Access Compliance Report

Public Rights-of-Way

(Curb Ramps)

Intersection ID: 25823	Main Street: BANNINGTON_RD	Cross Street: PINEVILLE-MATTHEWS_RD	Location: NW
ADA ID: 20A436846F9E	Ramp Type: PerpDiag	Initial Pass/Fail: Fail	Overall Compliance: No
		Severity Score: 12.5

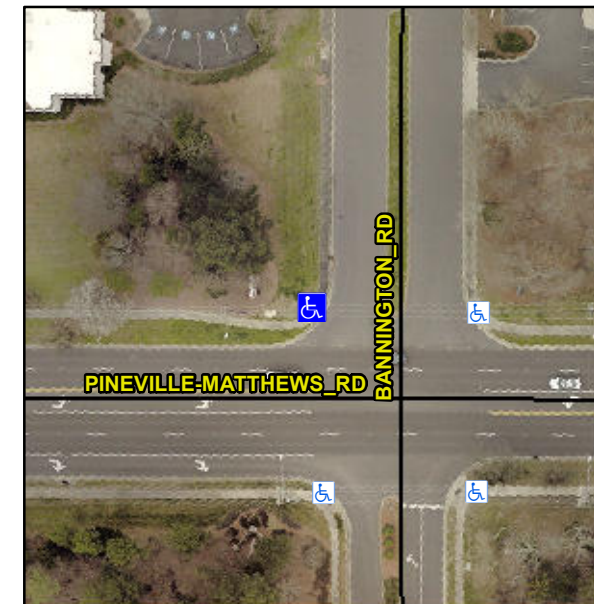
Not Found, R304.5.3

Compliance	Description	Data	Compliance	Description	Data
N/A	Ramp Length (in)	58.0	Yes	Ramp Slope (%)	5.5
Yes	Ramp Width (in)	48.0	No	Ramp XSlope (%)	5.6
N/A	Flare Type LT	N/A	N/A	Flare Type RT	N/A
N/A	Flare Slope LT (%)	N/A	N/A	Flare Slope RT (%)	N/A
N/A	Flare Traversable LT?	N/A	N/A	Flare Traversable RT?	N/A
N/A	Landing Length (in)	N/A	N/A	DWS Provided?	N/A
N/A	Landing Width (in)	N/A	N/A	DWS Contrast?	N/A
N/A	Landing Slope (%)	N/A	N/A	DWS Length (in)	N/A
N/A	Landing X Slope (%)	N/A	N/A	DWS Full Width?	N/A
N/A	Landing Curb? (Y/N)	N/A	N/A	DWS Offset (in)	N/A
N/A	Shared Landing?	N/A			
N/A	Gutter Ponding?	N/A	N/A	Gutter Slope (%)	N/A
N/A	Gutter Lip Ht (in)	N/A	N/A	Gutter X Slope (%)	N/A
N/A	Painted X Walk1?	No	N/A	Painted X Walk2?	No
	X Walk 1 Direction	To S		X Walk 2 Direction	To E
N/A	X Walk 1 Width (in)	N/A	N/A	X Walk 2 Width (in)	N/A
	X Walk 1 Slope (%)	5.6		X Walk 2 Slope (%)	3.1
	X Walk 1 X Slope (%)	1.8		X Walk 2 X Slope (%)	4.6

Remove & Replace Curb Ramp With Two New Directional Ramps or Equivalent.
